**ADDITIONAL INFORMATION REQUIRED FOR**

**ANACONDA COPPER COMPANY'S**

**JACKPILE-PAGUATE**

**RECLAMATION PLAN**

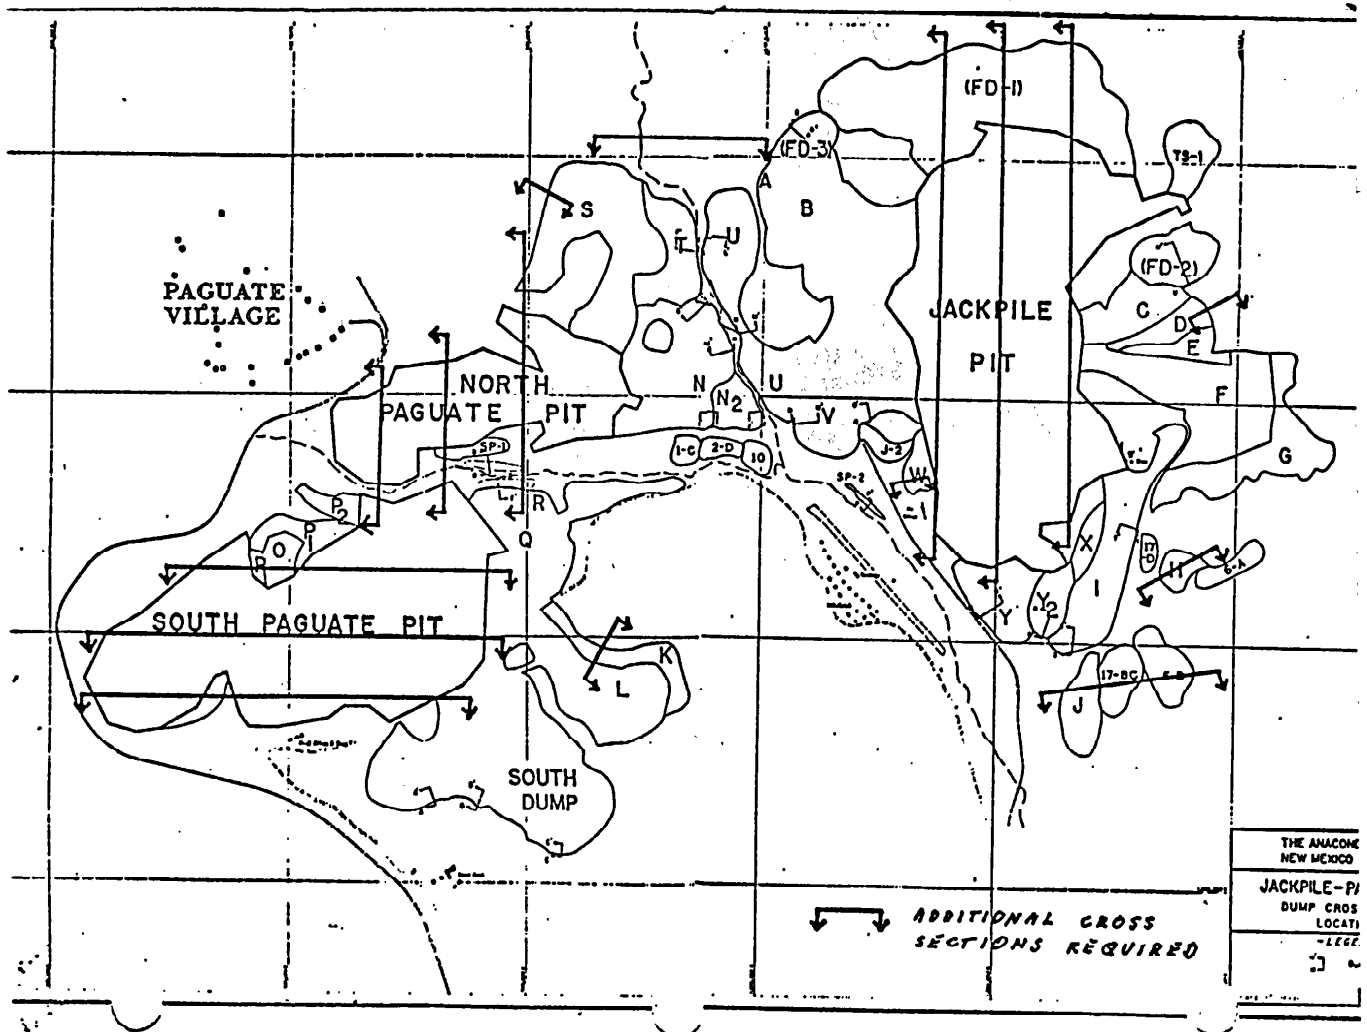
1. To adequately assess the final reclaimed land forms, additional detail must be provided. Please submit the cross-sections shown in red on the attached map.
